**LEXINGTON-FAYETTE URBAN COUNTY GOVERNMENT  
CONTRACT CHANGE ORDER**

Date:	August 27, 2015	R-583-2015 Contract #: 287-2014 Original R-744-2014
Project:	Public Safety Operations Center Phase 1B Renovation	
Location:	115 Cisco Road	
To (Contractor): Churchill McGee, LLC 1315-C West Main Street Lexington, KY 40508	Contract No.	287-2014
	Original Contract Amt.	\$6,109,000.00
	Cumulative Amount of Previous Change Orders	\$268,831.18
	Percent Change - Previous Change Orders	4.40%
	Total Contract Amount Prior to this Change Order	\$6,377,831.18
	Change Order No.	6

PROJECT: Public Safety Operations Center Phase 1B Renovation

CHANGE ORDER: 6

## Proposal Request 22

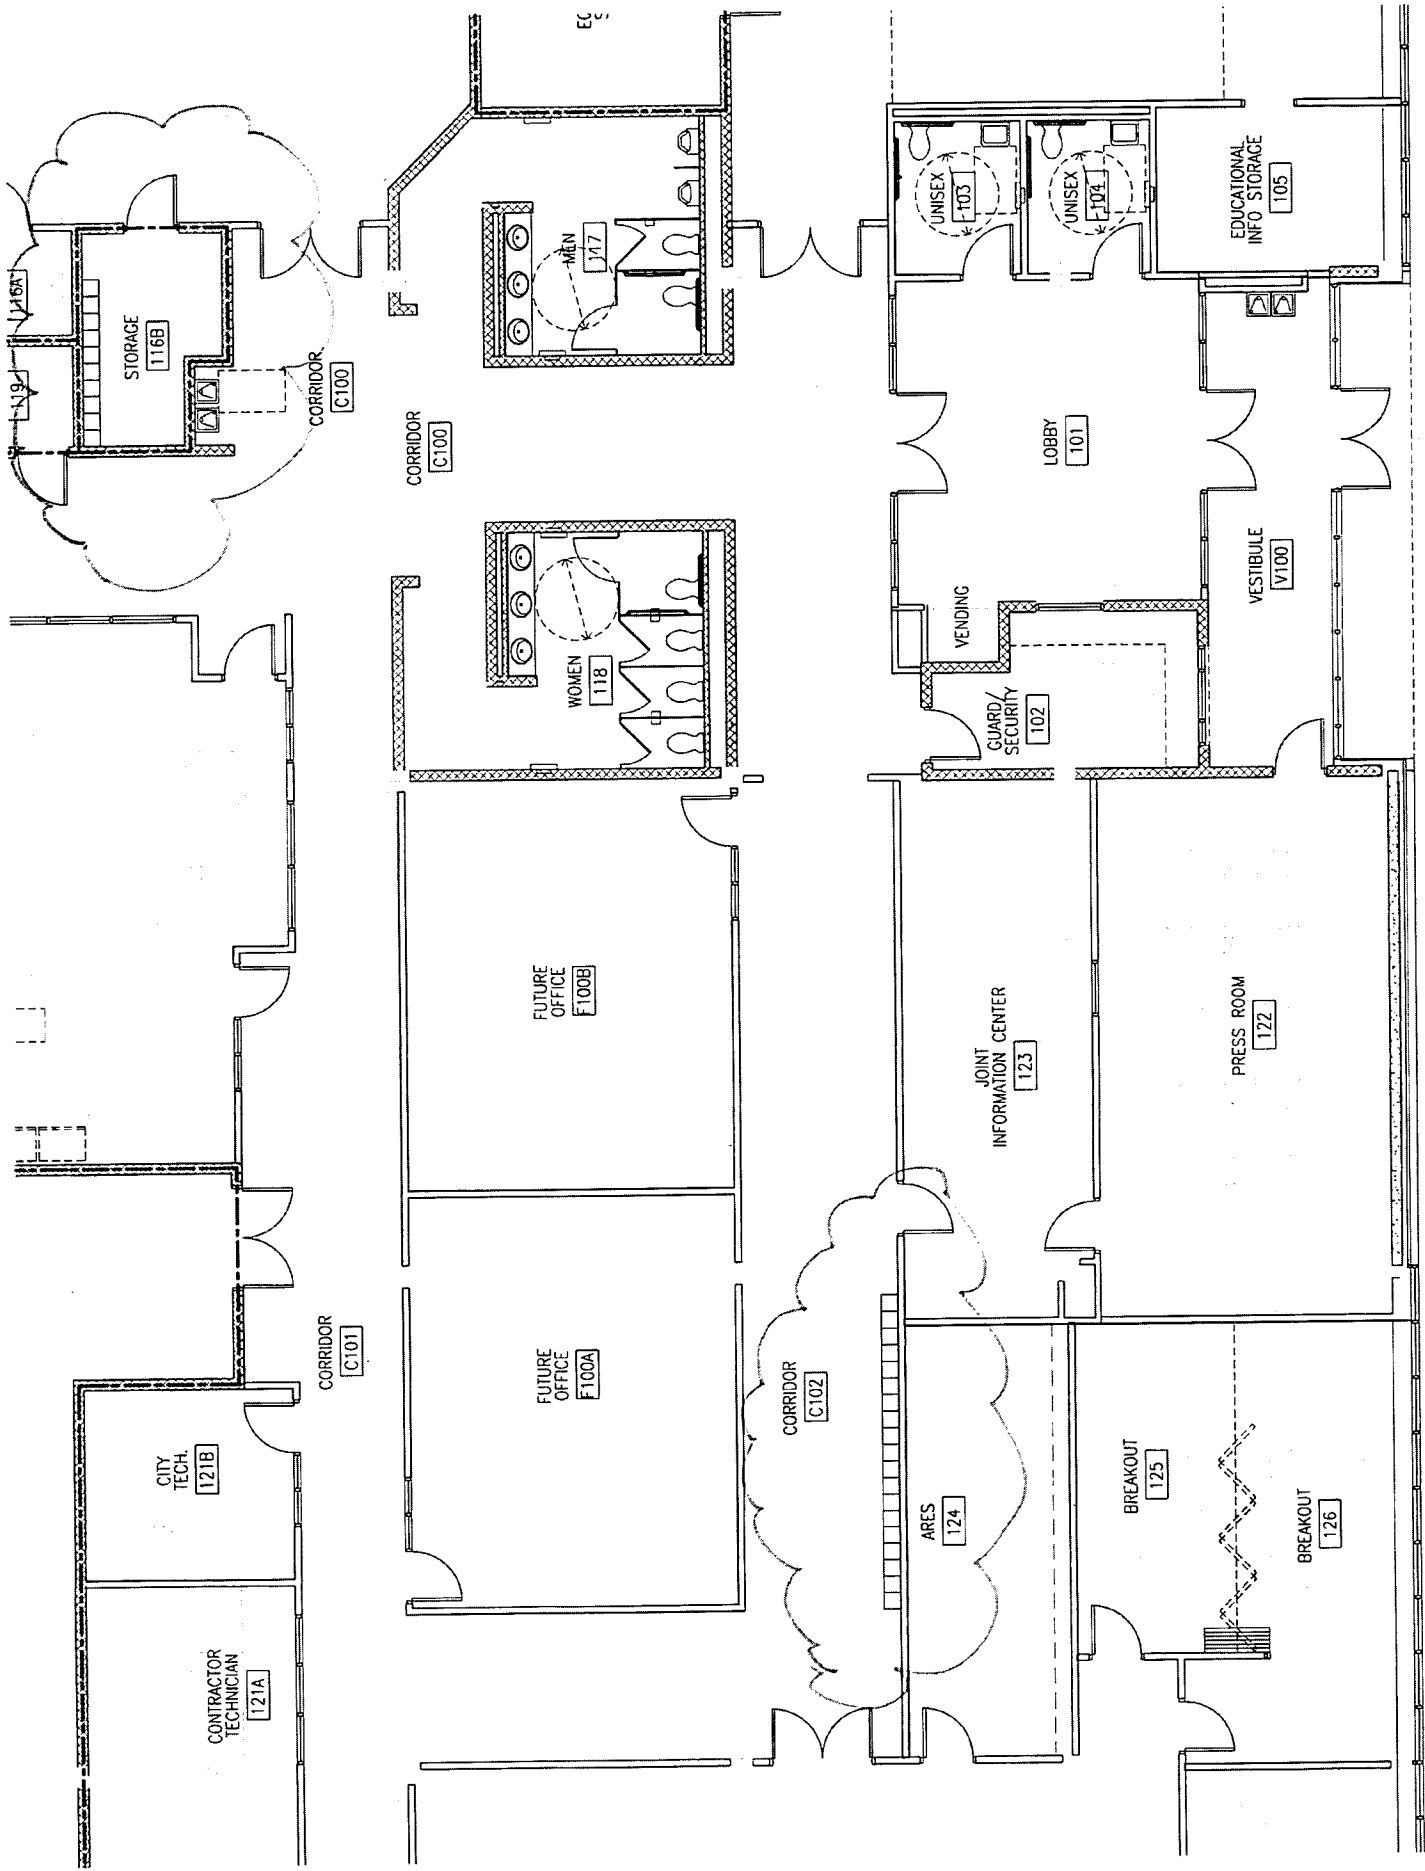
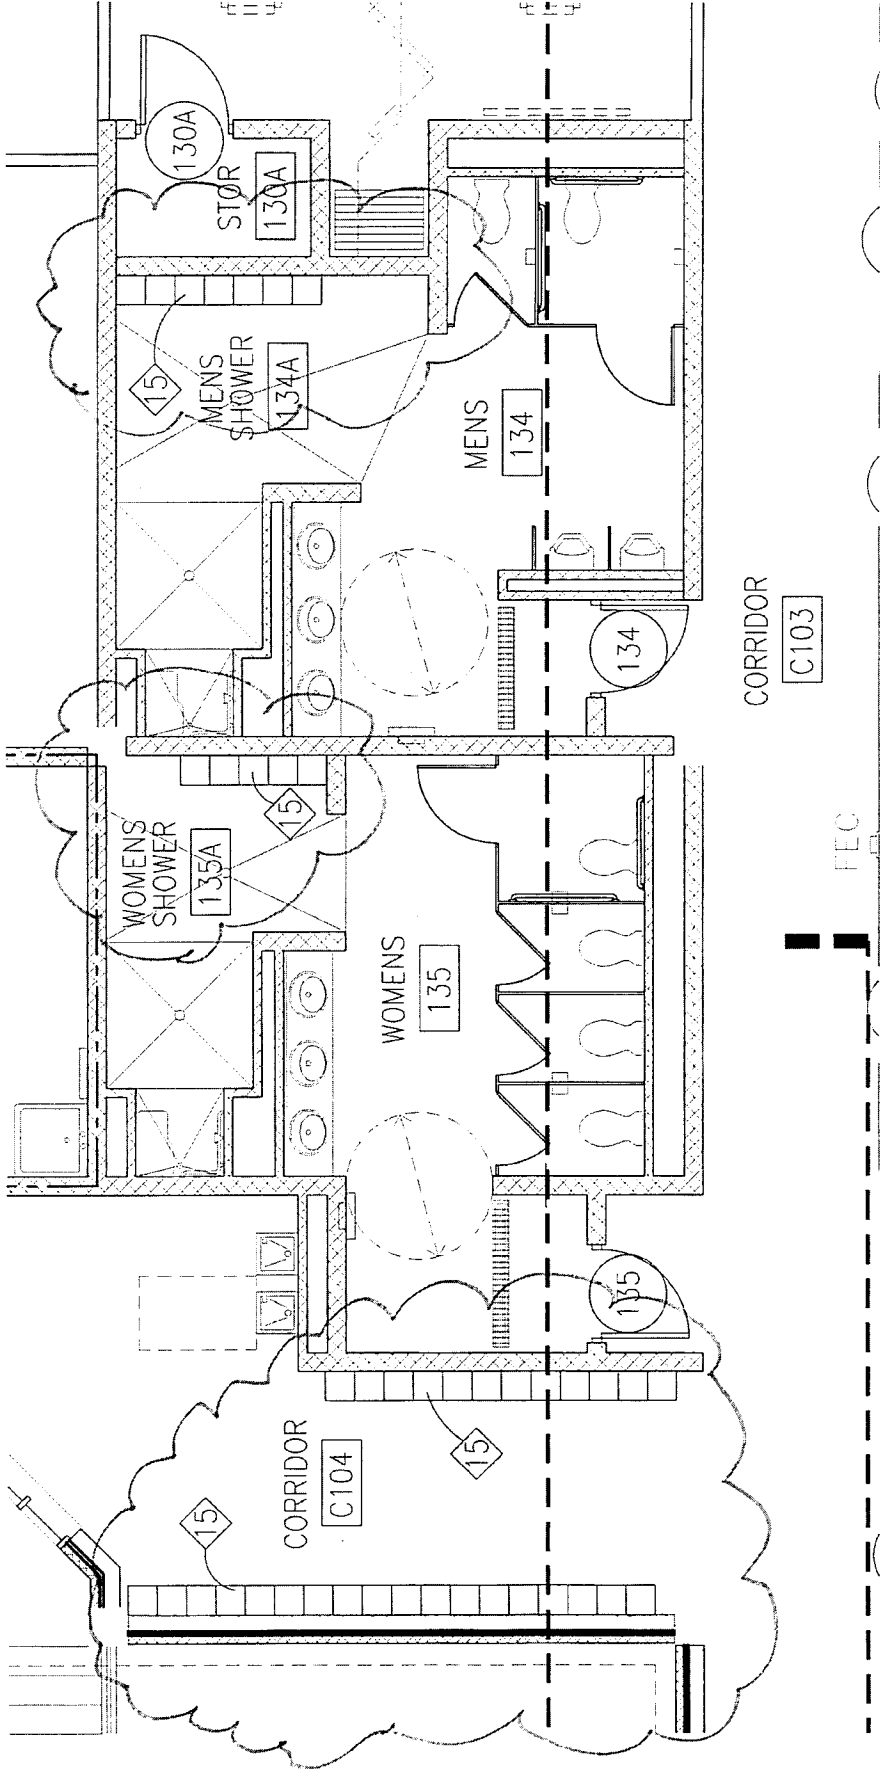
DELETE Lockers currently indicated on the floor plans (18"x18", single tier).

ADD new lockers in the spaces and arrangements indicated on attached sketches, as follows:

- Each locker shall be 12"x12" in plan, double tier unit.
- Other locker attributes shall be per spec section 105113 "Metal Lockers".
- Place as follows:
  - Storage 116B:
    - 10 lockers in plan (total of 20 lockers)
  - Corridor C102:
    - 19 lockers in plan (total of 38 lockers)
  - Corridor C104 - west wall:
    - 18 lockers in plan (total of 36 lockers)
  - Corridor C104 - east wall:
    - 12 lockers in plan (total of 24 lockers)
  - Men's Shower 134A:
    - 7 lockers in plan (total of 14 lockers)
  - Women's Shower 135A:
    - 5 lockers in plan (total of 10 lockers)
